**Meeting of the Central Valley Flood Protection Board
June 28, 2013
Staff Report**

Union Pacific Railroad Bridge 104.18 (Segment A), San Joaquin County

Consider approval of Permit No. 18841.

FIA FLOOD HAZARD BOUNDARY MAP
 No H 01

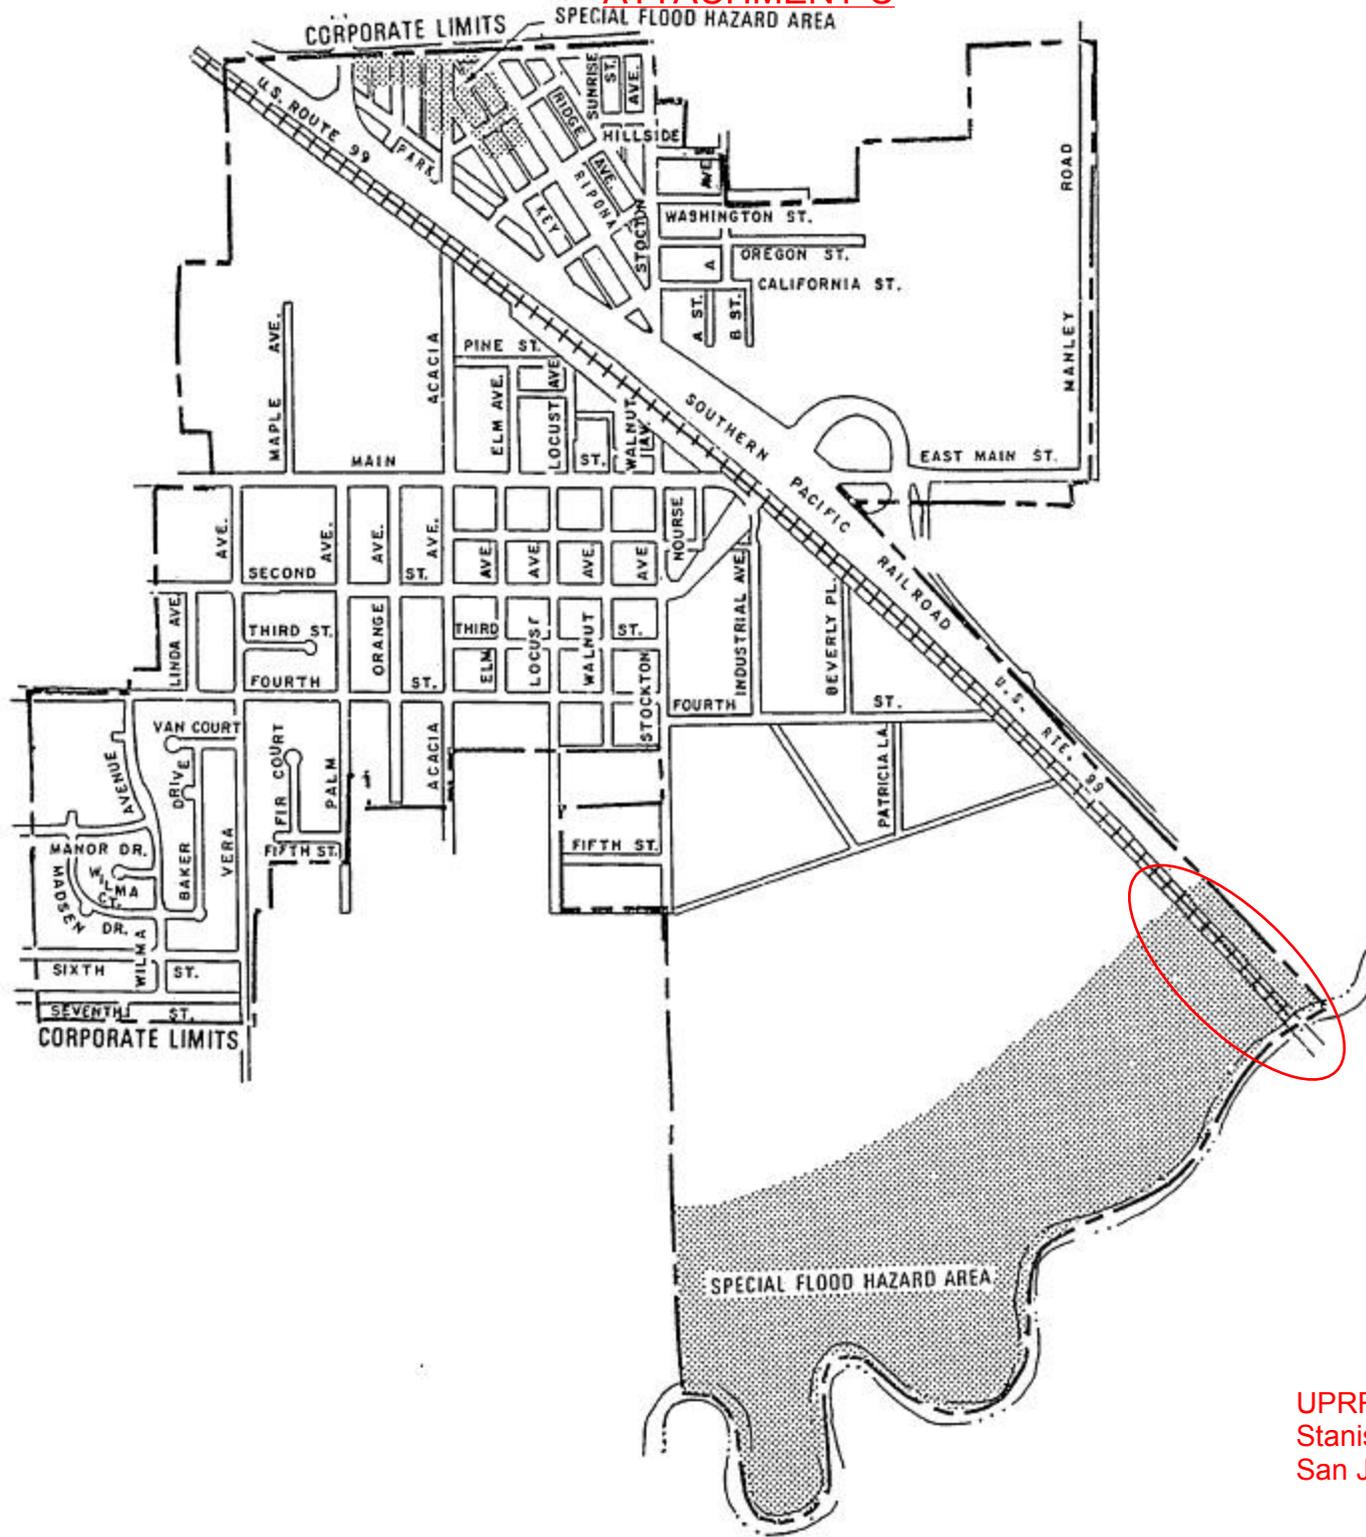
The first concern is placing fill in the CVFPB designated floodway, which is different than the FEMA effective floodway. The CVFPB's floodway is based on historic data, which is consistent with the 1975 FIRM for the City of Ripon, CA (attached). The current effective FEMA 100-year floodplain, dated 2009, is based on the best available data, which includes the construction of New Melones Lake in 1978 and the USGS stream gage located at UPRR Bridge 104.18 along the Stanislaus River. The stream gage has been active since 1938. I've attached a plan view showing both the CVFPB's designated floodway and the current regulatory 100-year floodway.

I spoke to David Williams at the Central Valley Flood Protection Board regarding the difference between the Board's Designated Floodway and FEMA's 100 year floodplain. The board's floodway is based on historic data, which is consistent with the 1975 FIRM for San Joaquin County. The current effective FEMA floodplain, dated 2009, is based on the best available data, which includes the construction of New Melones Lake in 1978 and the USGS stream gage located at Bridge 104.18 along the Stanislaus River.

EXISTING BRIDGE - UPSTREAM FACE PROFILE

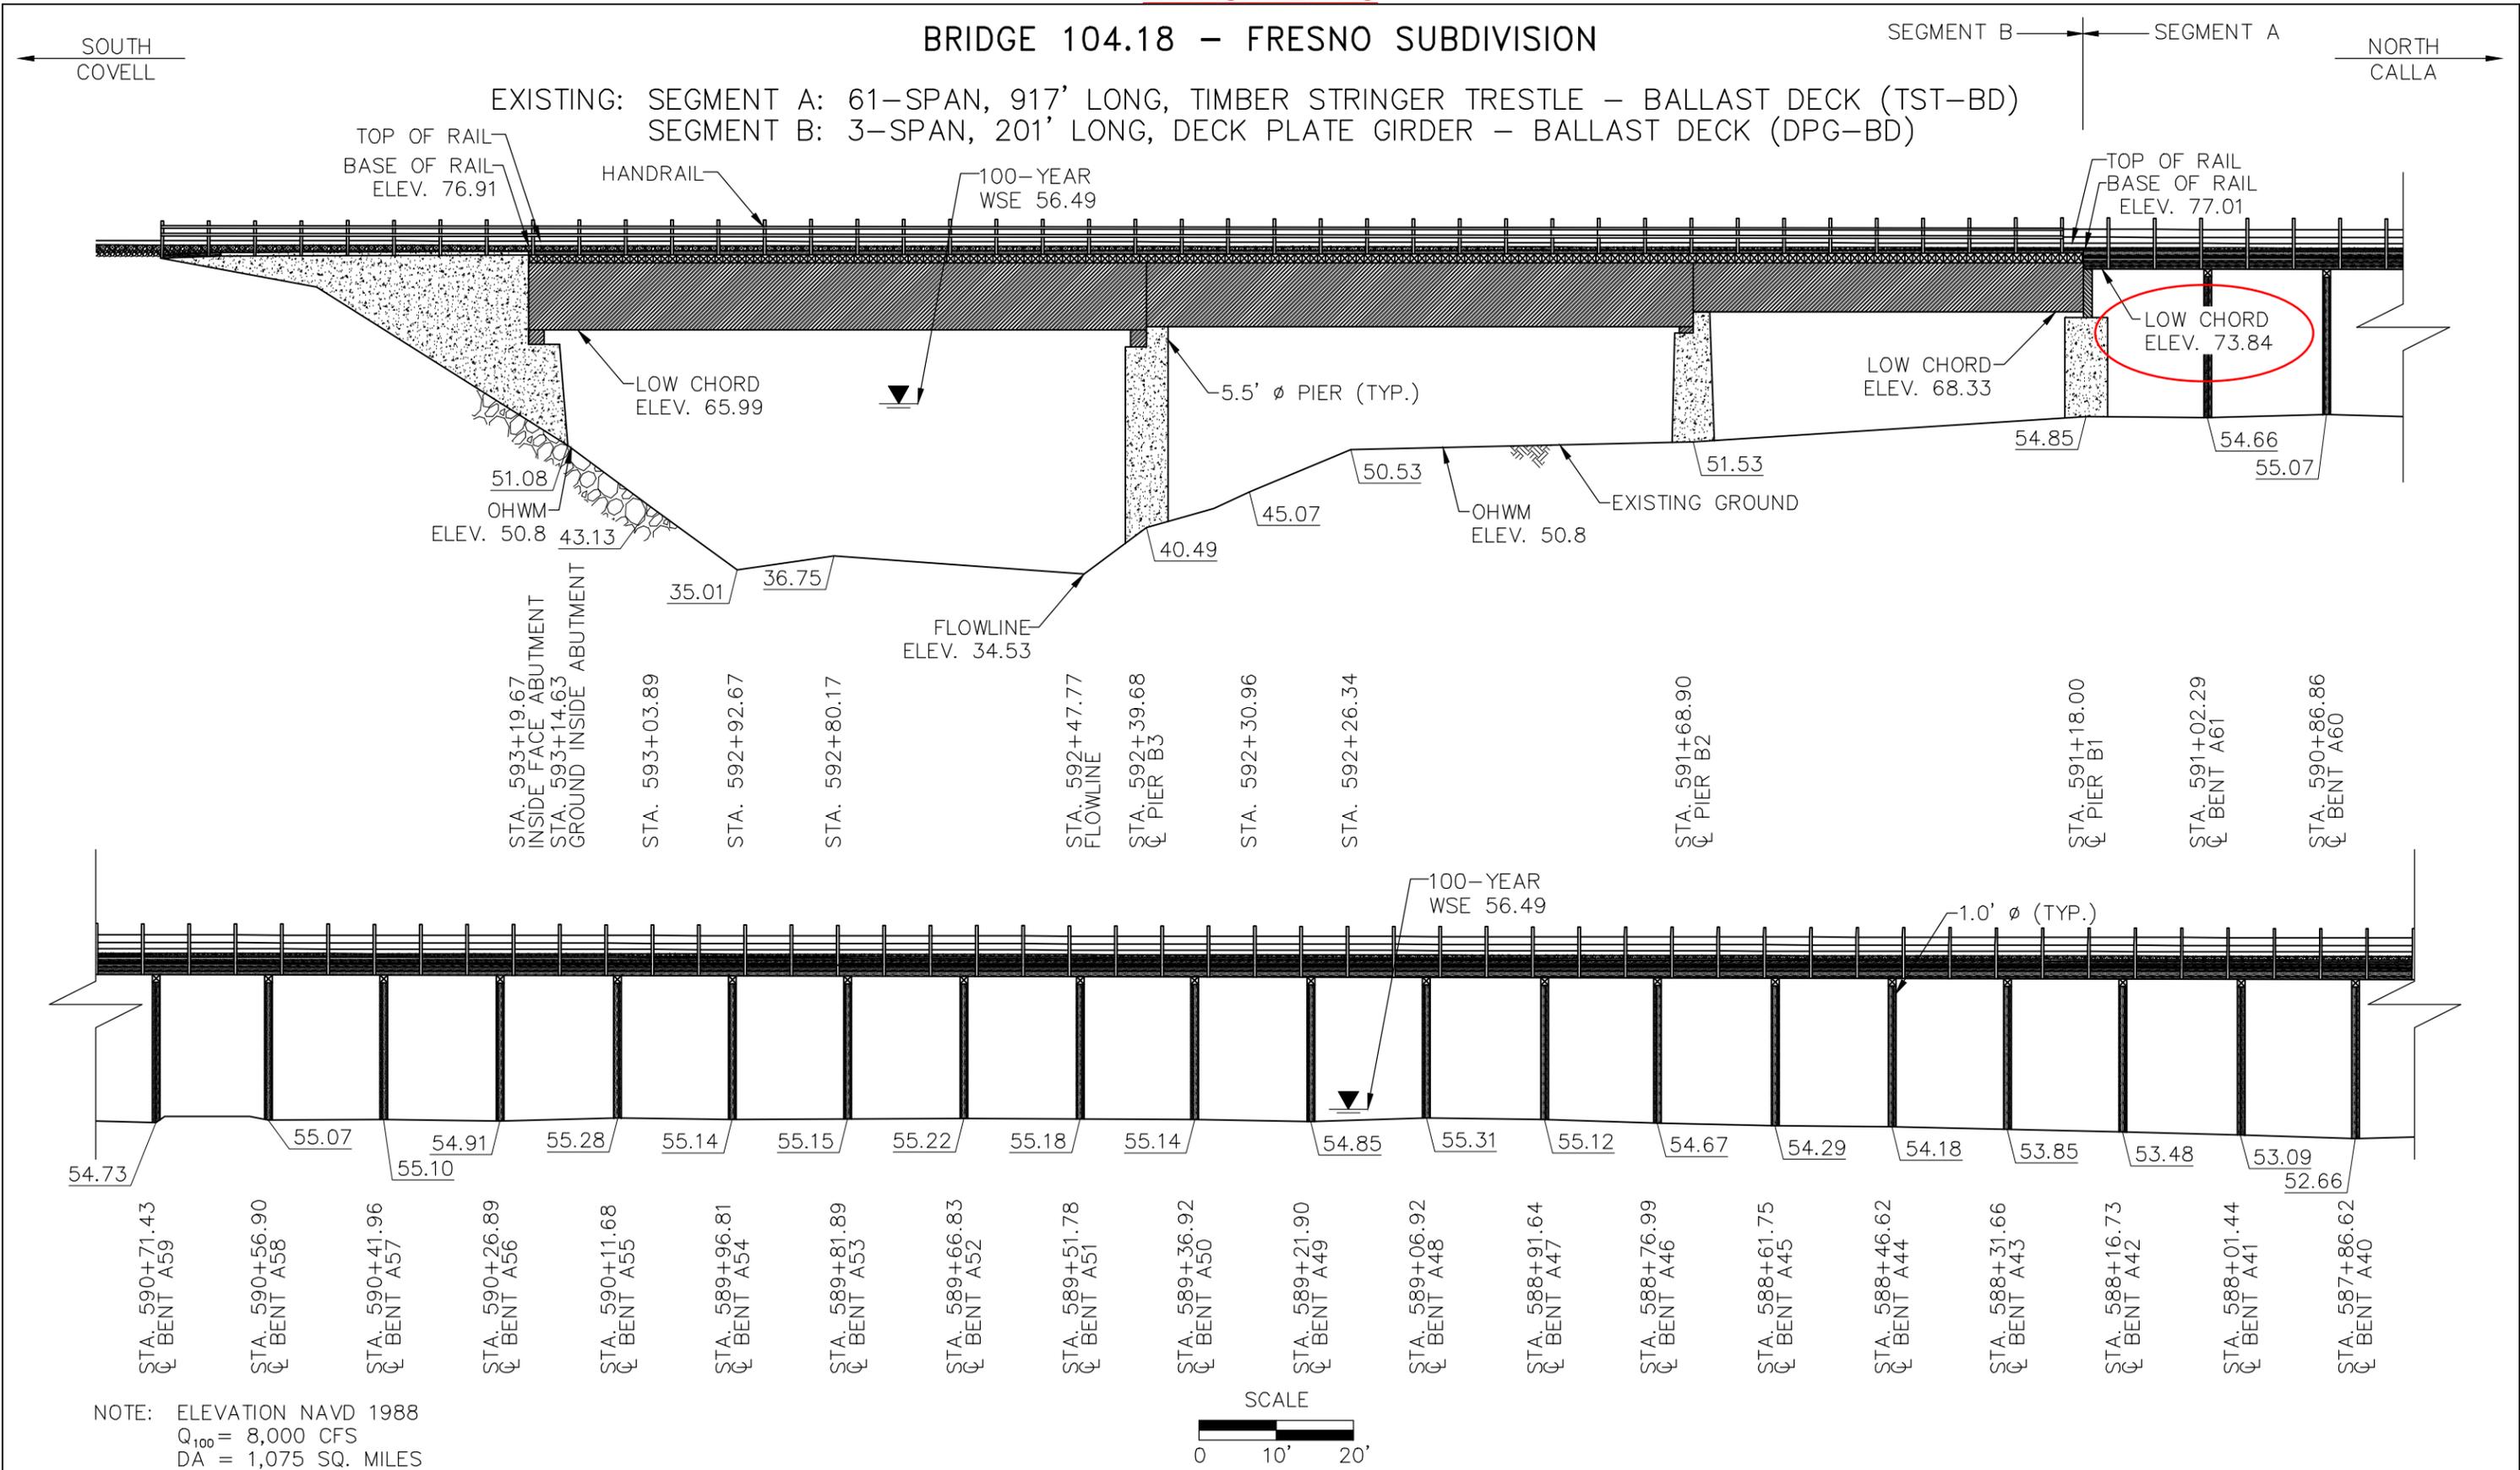
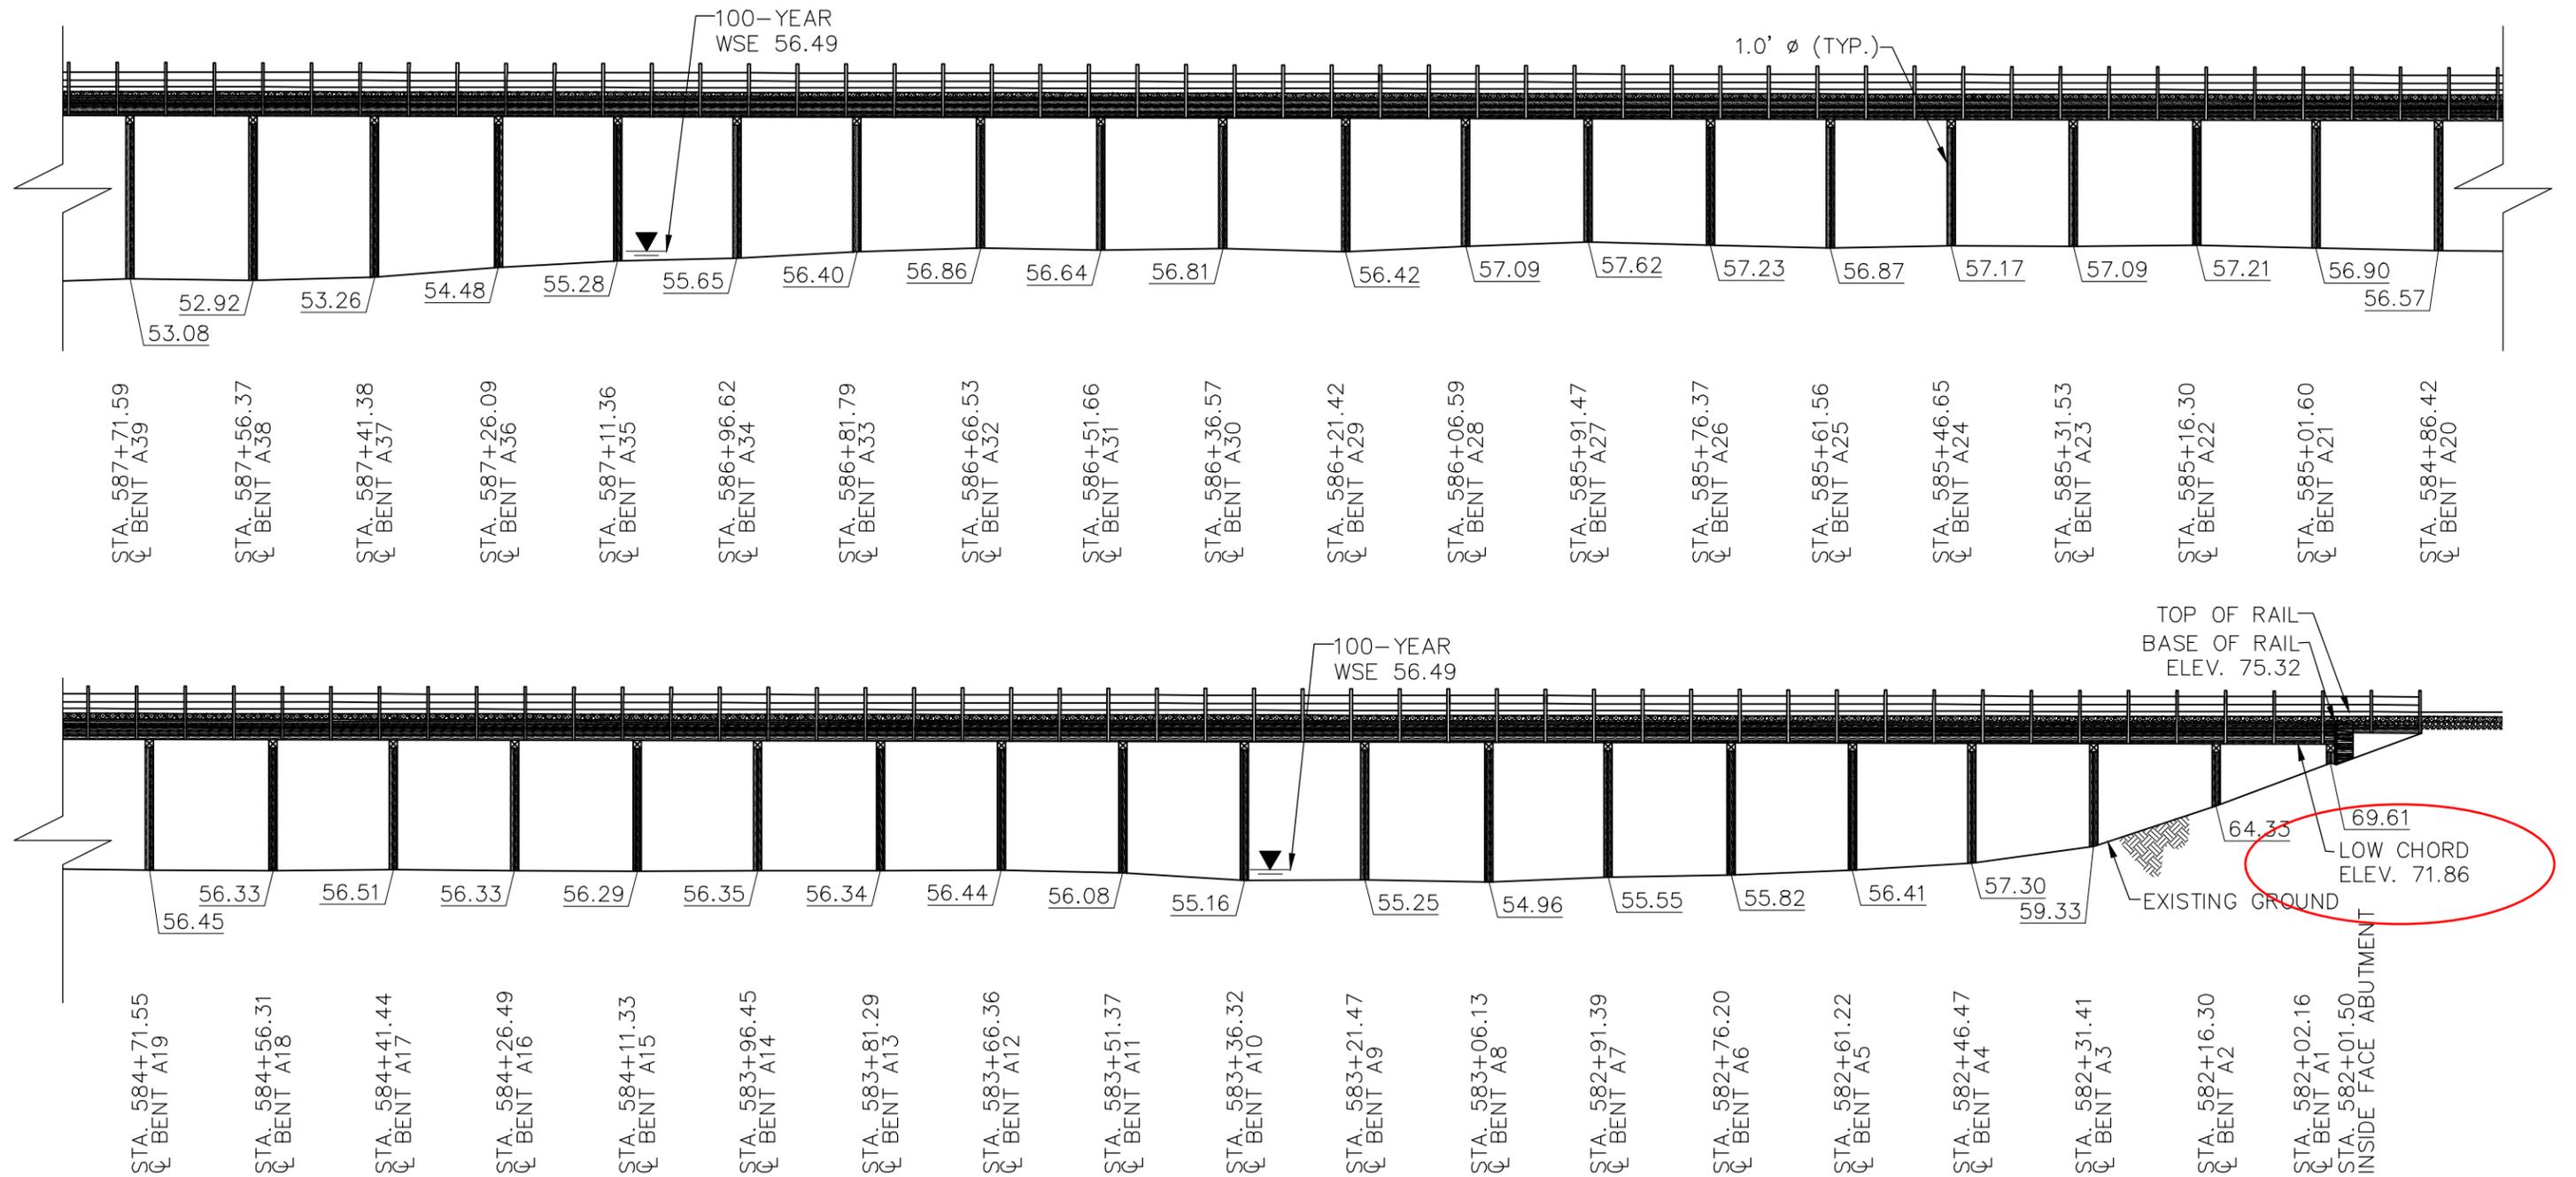
The second concern is lowering the low chord elevation of the proposed bridge. The county is referring to the low chord elevations at Pier B1, where the existing Segment A low chord elevation is 73.84 and the proposed low chord is 72.76. The proposed low chord elevation is lower due to the longer concrete replacement spans. It should be noted that the lowest low chord of the existing bridge along Segment A is at elevation 71.86 (TT North Abutment) and the lowest proposed low chord is at 72.05 (TT North Abutment), which is approximately 0.2' higher than existing. The HEC RAS model uses the lowest low chord elevation (most conservative) along Segment A. The 100-year WSE is at elevation 56.49, which is 15 feet below the proposed Segment A low chord elevation. I've attached an elevation view for your reference (Figures F-3A/B and F-4A/B).

Regarding your second question, the lowest low chord of the existing bridge along Segment A is at Elev 71.86 and the proposed low chord is at 72.05, approximately 0.2' higher. The HEC RAS model uses the lowest low chord elevation (most conservative). We always use the lowest, most conservative low chord elevation in our hydraulic analysis.
